ZONING CHANGE REVIEW SHEET

CASE: C814-89-0003.02 – 305 S. Congress PUD DISTRICT: 9

TO: PUD-NP, to change conditions of zoning

ADDRESSES: 305 S. Congress Avenue

305 S. CONGRESS PUD
Setbacks and Land Use Map

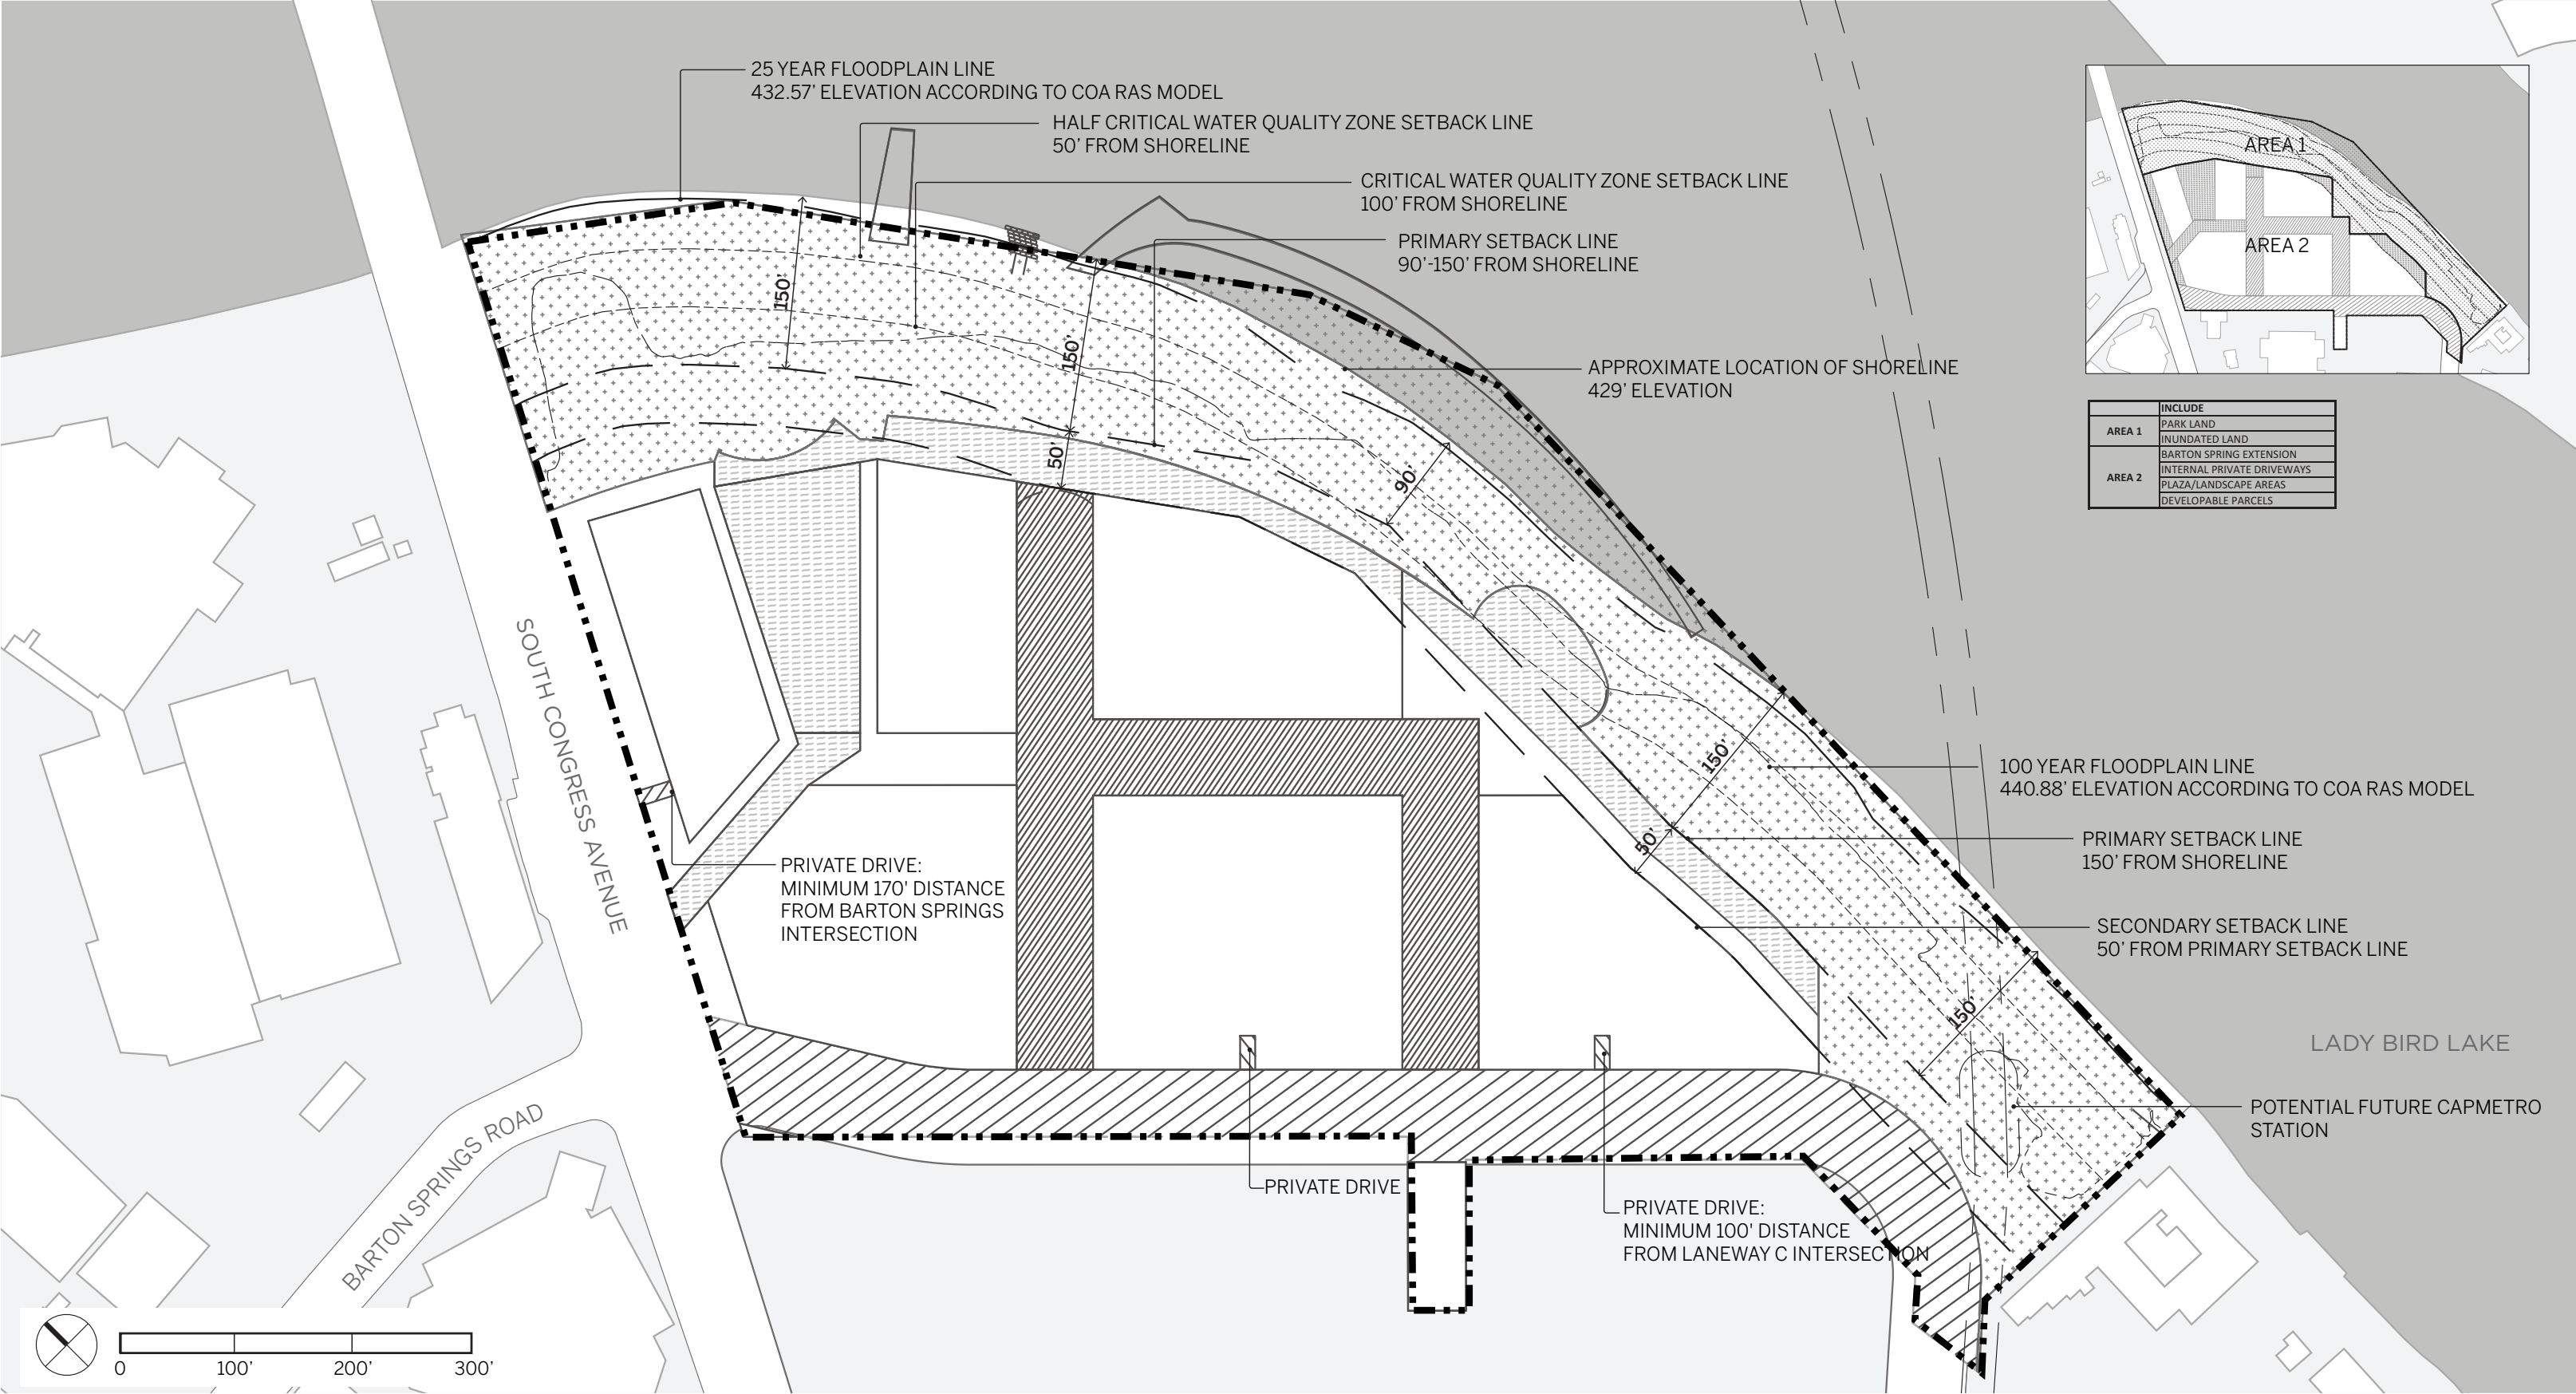
- a. Recommended by staff.
- Section 25-2-721(B)(2) (*Waterfront Overlay (WO) Combining District Regulations*) is modified to allow uses within Area 1, identified on the Setback and Land Use Map, to be consistent with the current allowable uses in the Public Zoning District.

- a. Recommended by staff.
- Sections 25-2-742(B)(1) (*South Shore Central Subdistrict Regulations*) is modified to reduce the primary setback line to 90 feet landward from the shoreline as shown on the Land Use Plan.

305 S. CONGRESS PUD
Conceptual Open Space Map

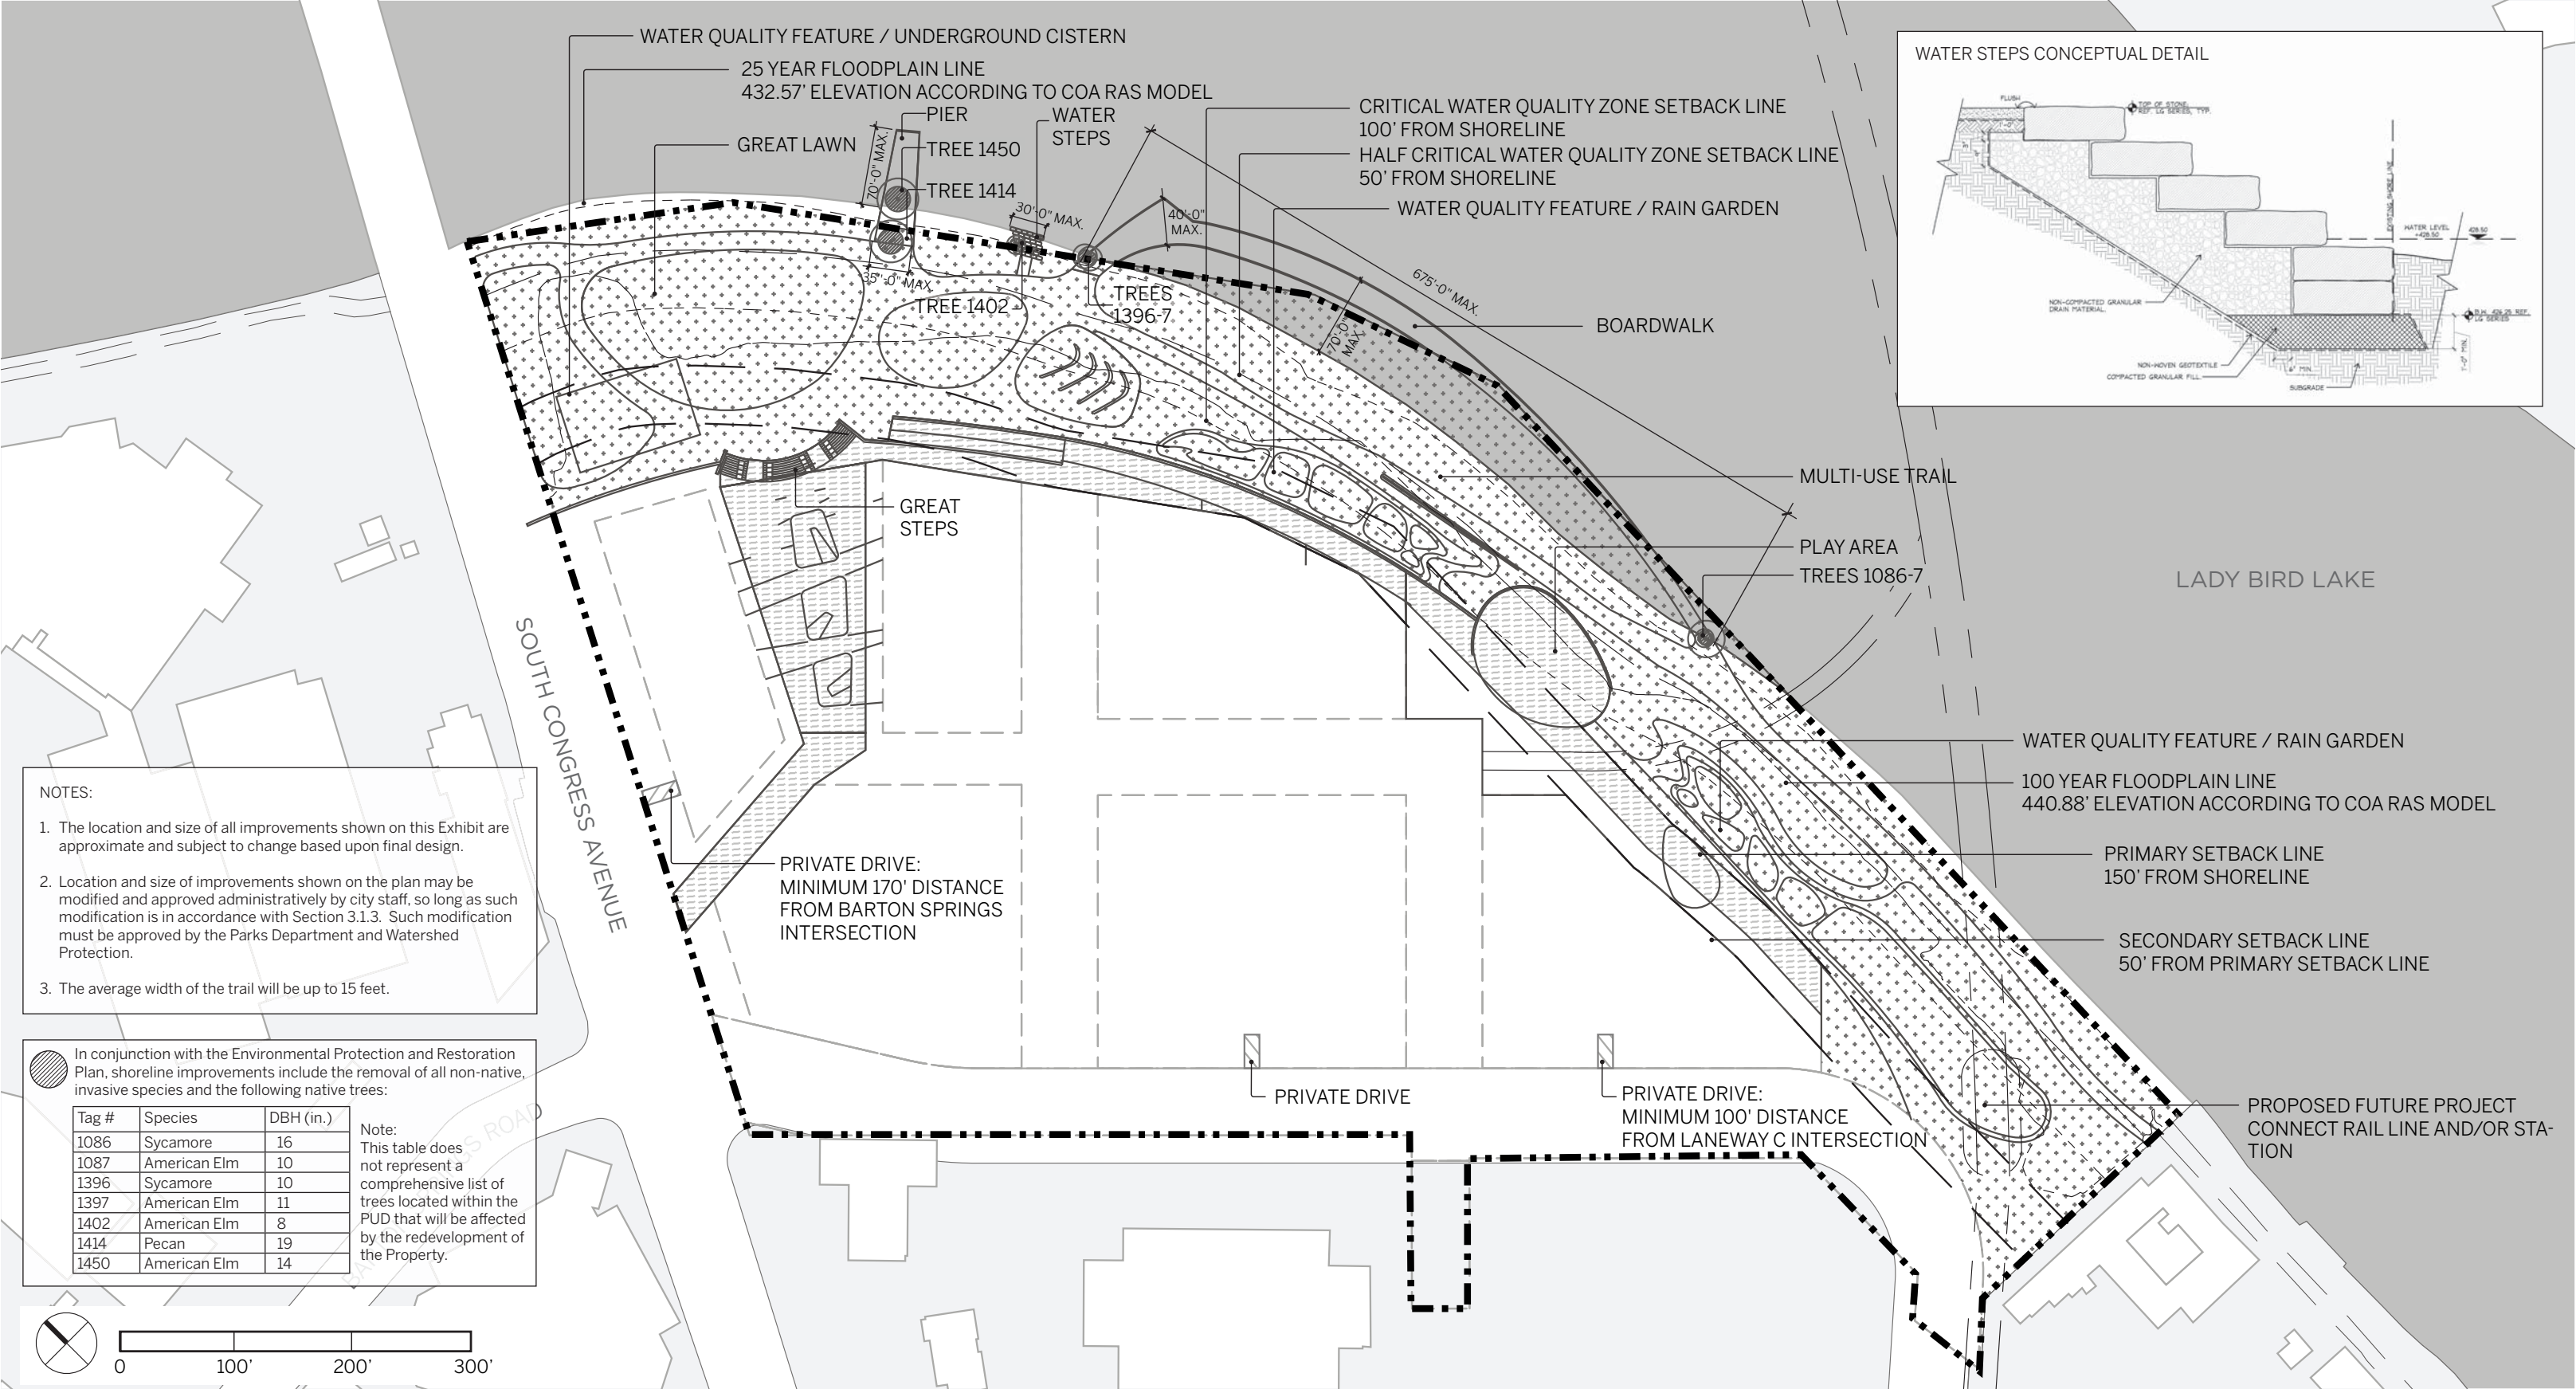
- a. Recommended by staff.
- **Section 25-2-1176(A)(4) (*Site Development Regulations for Docks, Marinas and Other Lakefront Uses*) is modified to allow for construction of the elements and dimensions shown on the Conceptual Open Space Map. The boardwalk is not to exceed 675 linear feet of shoreline frontage.**

Figure 2: Mitigation Map

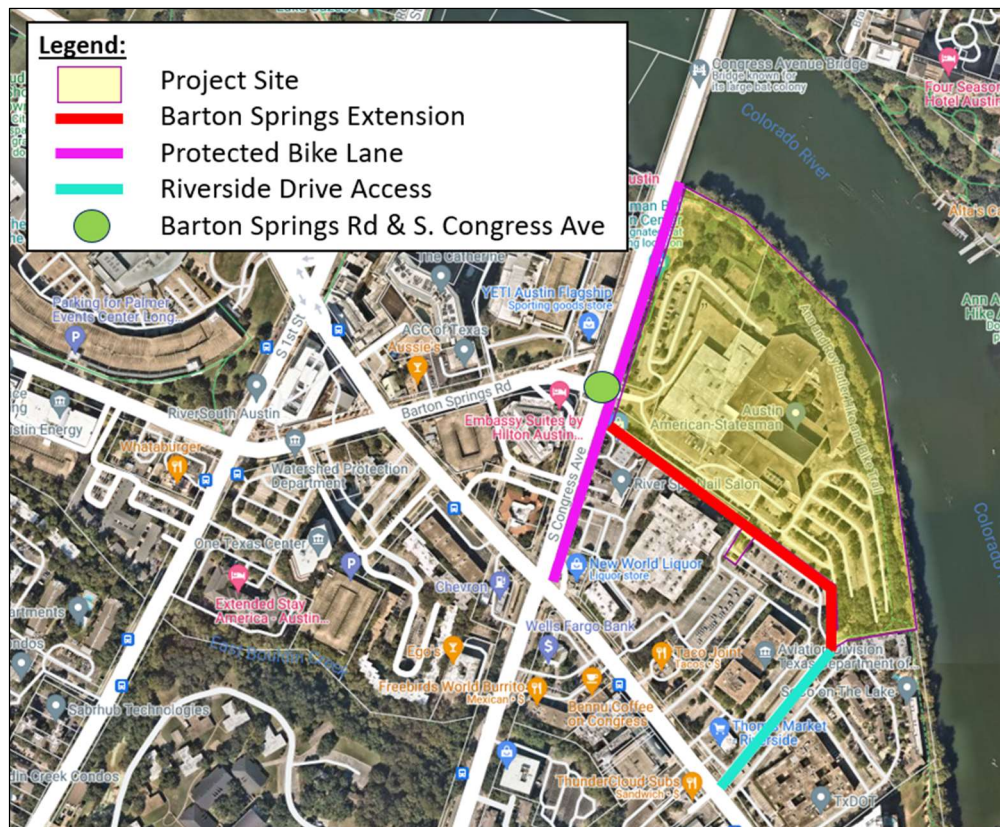
1. The applicant shall design and construct the improvements identified in Table 2 below and in Figure 2 prior to issuance of a temporary certificate of occupancy (TCO) or certificate of occupancy (CO) for the first building requiring a CO.
2. The applicant shall dedicate, design, and construct the Barton Springs Extension prior to the issuance of the **first** temporary certificate of occupancy (TCO) or certificate of occupancy (CO) for the first building requiring a CO. The Barton Springs Extension will be constructed by this development in accordance with the PUD ordinance, as shown in Figure 3.
3. The applicant shall incorporate bicycle and pedestrian facilities along the Riverside Drive Access with construction of the Barton Springs Extension which will be with the first building requiring a CO, subject to ATD approval.
